**From:** Habib, Donald  
**Sent:** Friday, June 22, 2018 5:00 PM  
**To:** Vogtle PEmails  
**Subject:** LAR-17-037 - Draft Reviewer's Aid - Roll-up of Original LAR plus supplements  
**Attachments:** LAR-17-037\_Roll-up of Changes in S1 - S3\_NRC Copy.pdf

**Vogtle Electric Generating Plant (VEGP) Units 3 and 4**

**Enclosure 4U**

**Proposed Tier 2\* Departure Evaluation Process**

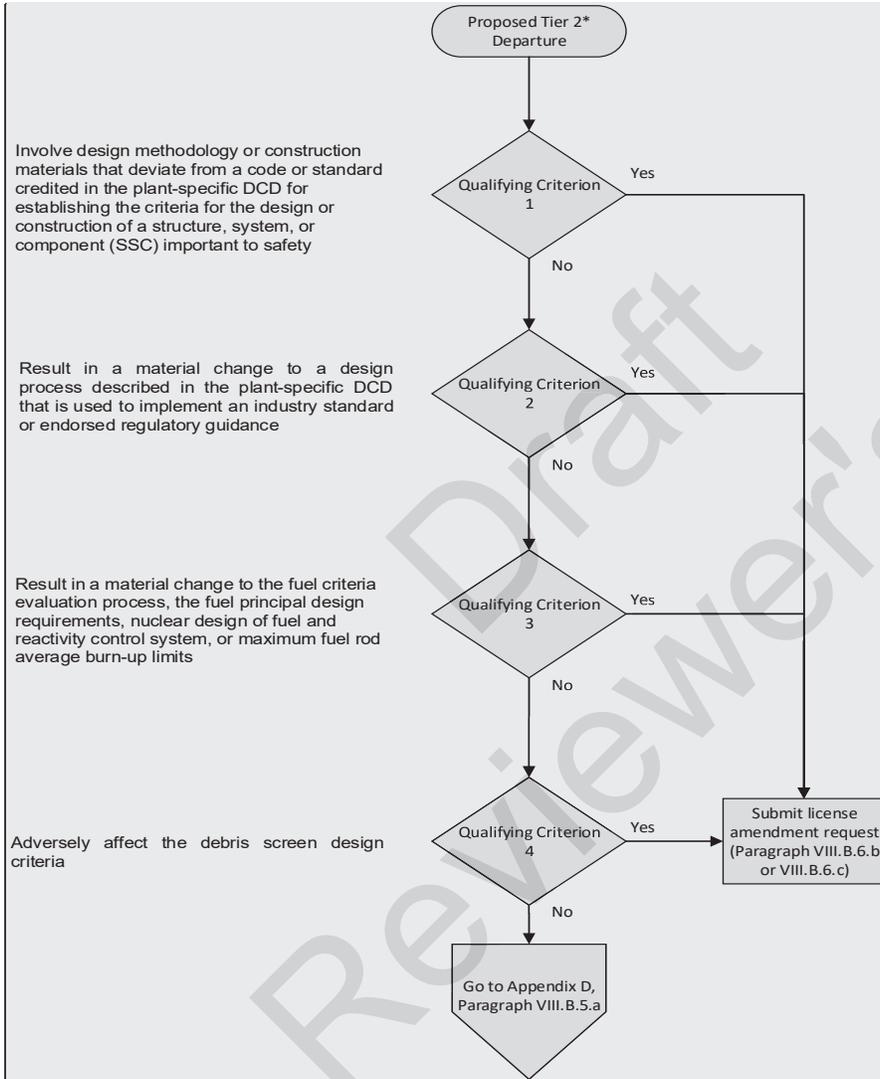
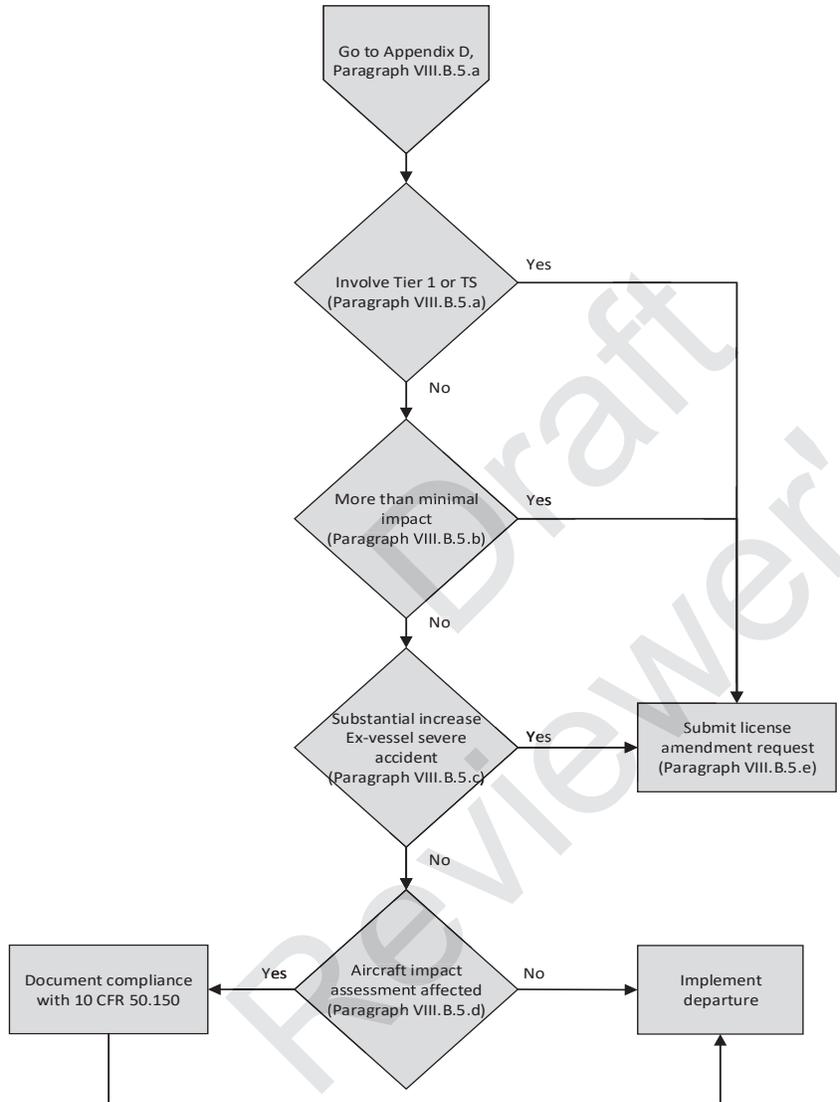
**Commented [HN42]:** Revise decision box for Qualifying Criterion 3 – Fuel

**Commented [HN43]:** Revise decision box for Qualifying Criterion 4 – Screens

Response to RAI LAR-17-037-3 (MCB) in LAR 17-037S2 (ND-18-0608, Enclosure 11, pg. 4).

Response to RAI LAR-17-037-9 (SRSB) in LAR-17-037S3 (ND-18-0646, Enclosure 17, pgs. 4 & 9).
